HARBORD VILLAGE RESIDENTS' ASSOCIATION

PW13.8: Toronto Street Furniture Program – Proposed Info Pillar Placement Guidelines

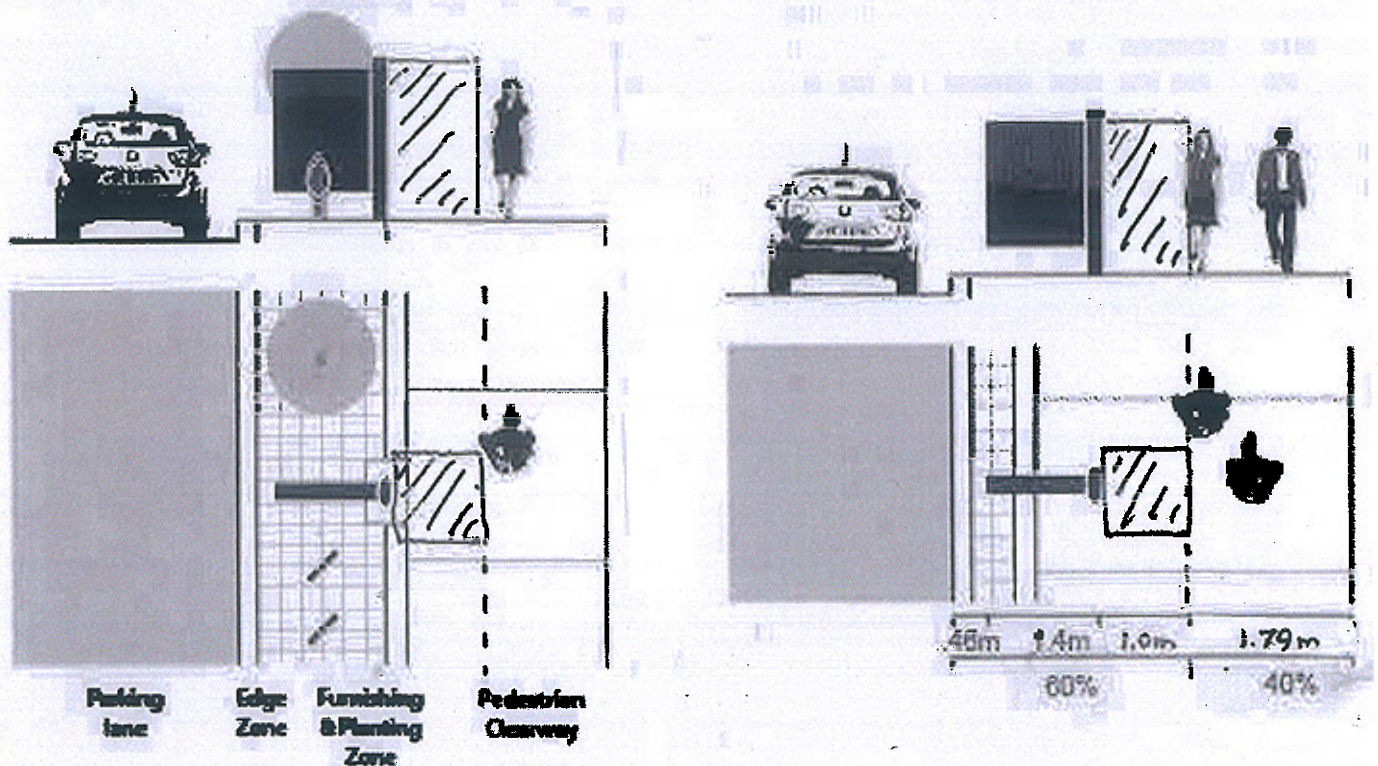
We object to this principle. We suggest there is no need for it, and it is misleading in its current form. While the principle is directionally correct, and reinforces the importance of containing furnishings to a defined Furnishing Zone for pedestrian benefit. However, it is misleading, in that Staff inappropriately present furnishing zone placement as the "optimal" location implying it is somehow discretionary –when it is the only street furnishing location that is allowed by Vibrant Streets Guidelines or the Accessibility Design Guidelines. This principle also falls short in that it overlooks the Vibrant Streets Guideline (S7.6) that "No furniture will be placed within the Pedestrian Clearway zone or such that use of the furnishing will interfere with the Clearway." With Info Pillars placed perpendicular to the curb, the Clearway obstruction is in the order of 1m – allowing space to view the tall, narrow maps as well as the obstruction from backpacks, wheelchairs, etc. The impact is illustrated here.

- We support Principle 3 for added clarity, but ONLY if rewritten to read: The *optimal-permitted* location for Info Pillars (***subject to meeting all other Guidelines***) is completely within the Furnishing and Planting Zone of the sidewalk, ~~where~~-***if*** they can be appropriately integrated into the streetscape and not impede the passage of pedestrians ***when way-finding maps are being used.***
